Addendum #1

**Alterations 2022
Piqua High School
Piqua City Schools**

February 4, 2022

Print Record	02/04/22 ADDENDUM 01
Project Number	2021-203
Date	February 4, 2022
Sheet Title	WIREWAY DETAIL
Sheet Number	SK-1

EAST WALL GYMNASIUM WIREWAY DETAIL

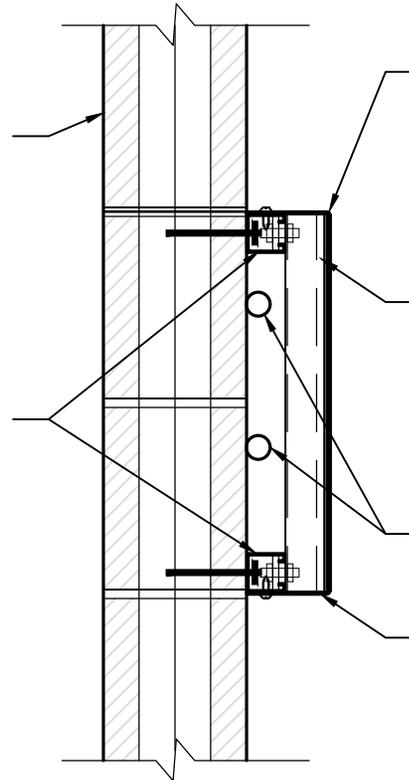
11. Sketch Sheet SK-1: NEW SUPPLEMENTAL DRAWING
 - 11.1. This detail clarifies the requirements for the Wireway noted on elevation A/A2.82.
12. Drawing Sheet E2.02: First Floor Enlarged Power Plan – New Work: REPLACE the previous sheet with the version attached to this addendum. Revised as noted:

CONTINUOUS HORIZONTAL UNISTRUT P1000 ANCHORED TO EX. CMU WALL W/ 1/2" ϕ THREADED RODS W/ HILTI HIT-HY TO ADHESIVE & MESH SLEEVES [HILTI-SC 18x85] AT 32" O.C.

INSTALL 18 GA. x 2" WIDE STEEL STRAP AT EACH VERTICAL SEAM, POWDER COAT TO MATCH P-2 - ATTACH TO UNISTRUT W/ [2] 1/4" STAINLESS STEEL SELF TAPPING SCREWS TOP & BOTTOM.

INSTALL VERTICAL UNISTRUT P1000 W/ P3184 CLOSURE STRIP AT ALL METAL STUD TRACK SEAMS [$\pm 8'-0"$ O.C.] - ATTACH VERT. TO HORIZ. UNISTRUT W/ BOLT, WASHER, AND NUT PER MFR. -

EXISTING S.M. CONDUITS & BOXES TO REMAIN - NOTCH UNISTRUT & TRACK AS REQ'D

1600T350-68 METAL STUD TRACK IN 10'-0" SECTIONS, POWDER COAT TO MATCH P-2 - ATTACH TO UNISTRUT W/ 1/4" STAINLESS STEEL SELF DRILLING SCREWS AT 16" O.C. TOP & BOTTOM.
